Contract Change Request

Project Number: 40-00328 Project Name: H - Menger Creek Drainage

Record Number: CCR-0000023 Status: Pending Contract #: 4600014864 Title: TCI-05 Trail Lighting

Re: 40-00328, Menger Creek Drainage Change Request No.6 - Trail Lighting

ES1.1

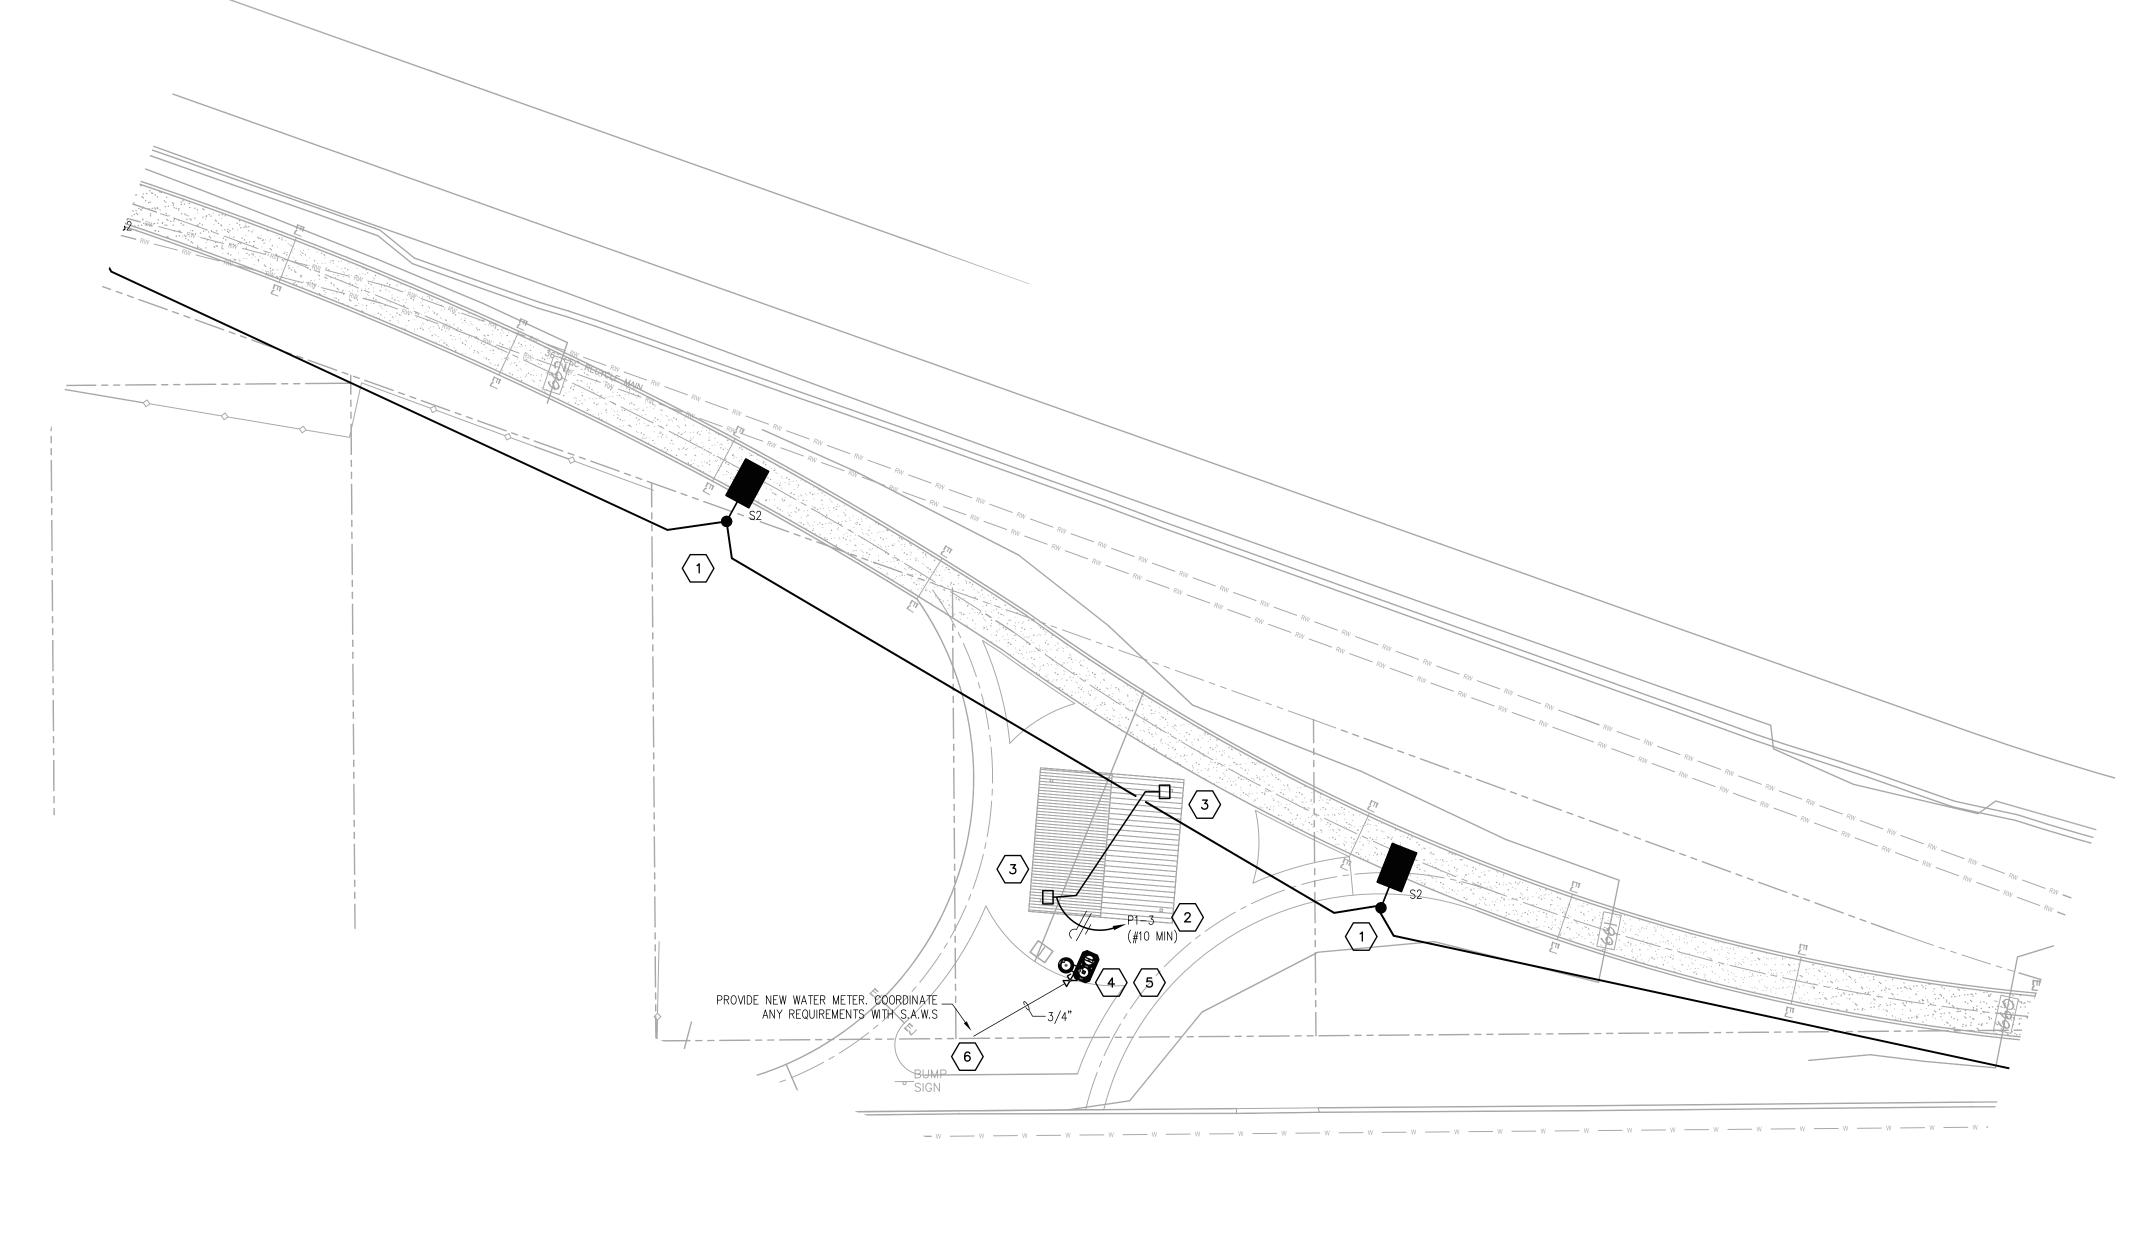
Description of Change: This change order is for trail lighting installation for the Menger Creek project. Reference attached.

Justification for Proposed This change order is necessary to add Trail Lighting to the contract that was originally Change: covered by ADD Alt #10.

Exclusions/Conditions specific to this proposal: Electrical installation for sheets ES1.1, ES1.2, ES1.3, ES1.4, ES1.5, E.4, E.5, does not include electrical on EPS1.0. Reference attached proposal 'A'. Additional Exclusions not shown on attached, Night Work, off-duty officers, boring, sales tax, CPS usage fees and service set up fees.
